TENNESSEE VALLEY AUTHORITY

JUSTIFICATION OF THE SEISMIC DESIGN CRITERIA USED FOR THE SEQUOYAH, WATTS BAR, AND BELLEFONTE NUCLEAR POWER PLANTS

PHASE II

RESPONSES TO NRC QUESTIONS 1 THROUGH 6

FIGURE Q3-6

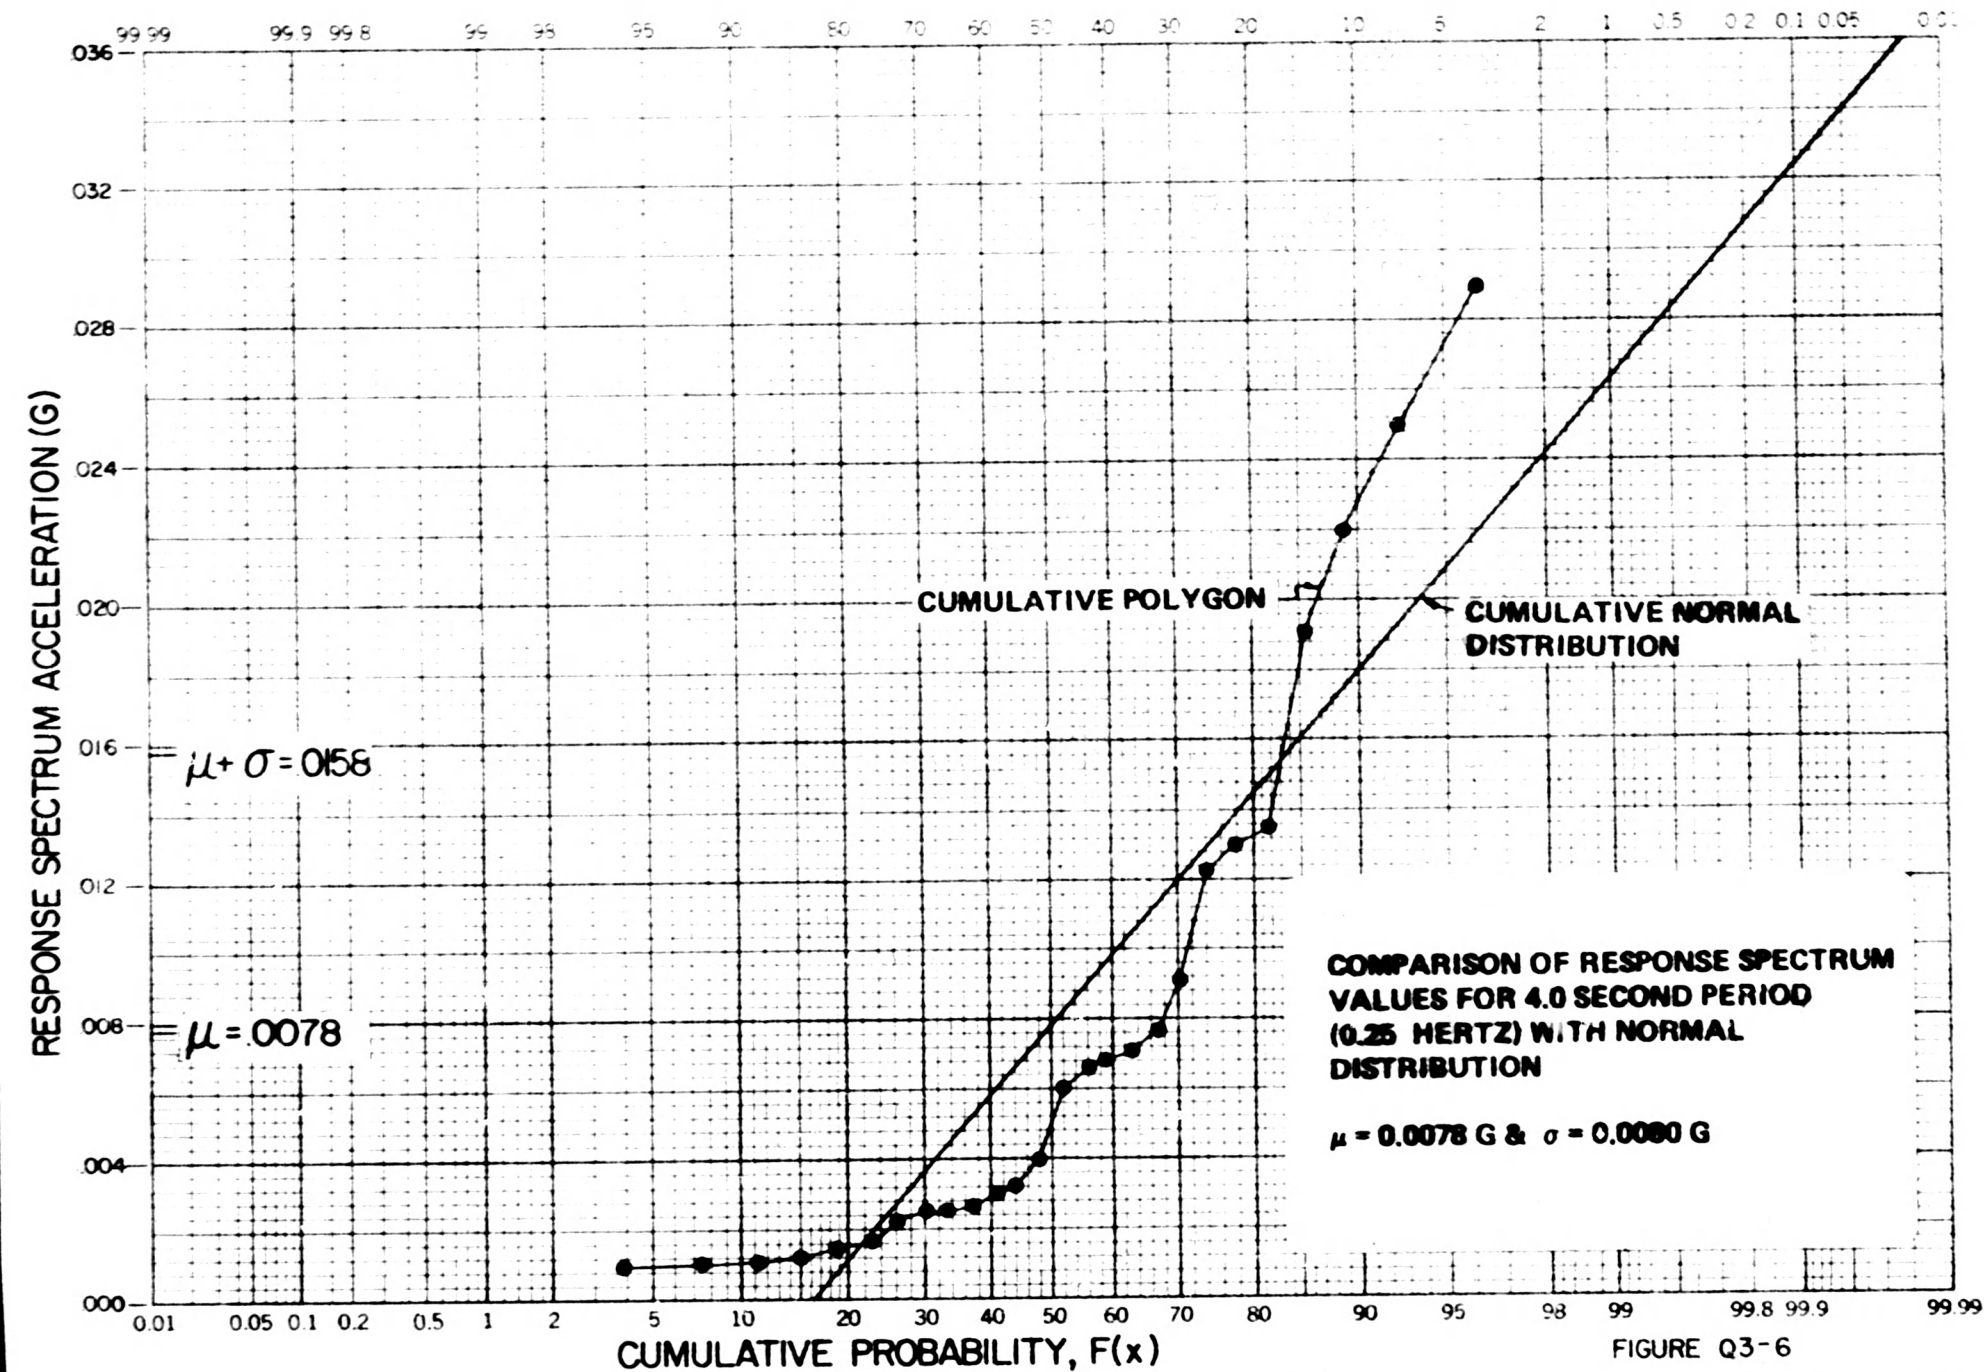
3. Determine whether the distribution of response spectral values at each frequency for the available data is better fit by a normal or lognormal distribution. Calculate 50th and 84th percentile spectra for the appropriate distribution.
4. Determine to what percentile different frequency bands of the design spectra correspond to with respect to the distribution calculated in 3. Discuss the significance of each such frequency band to the engineering analysis of structural components.

Figures Q3-3 through Q3-10 compare the actual data to each assumed distribution. For this comparison only the response spectra for 4 percent damping are used. Figures Q3-3 to Q3-6 compare the actual data to an assumed normal distribution for peak acceleration values and spectral values at periods of 0.15, 0.40, and 4.0 seconds, respectively. Figures
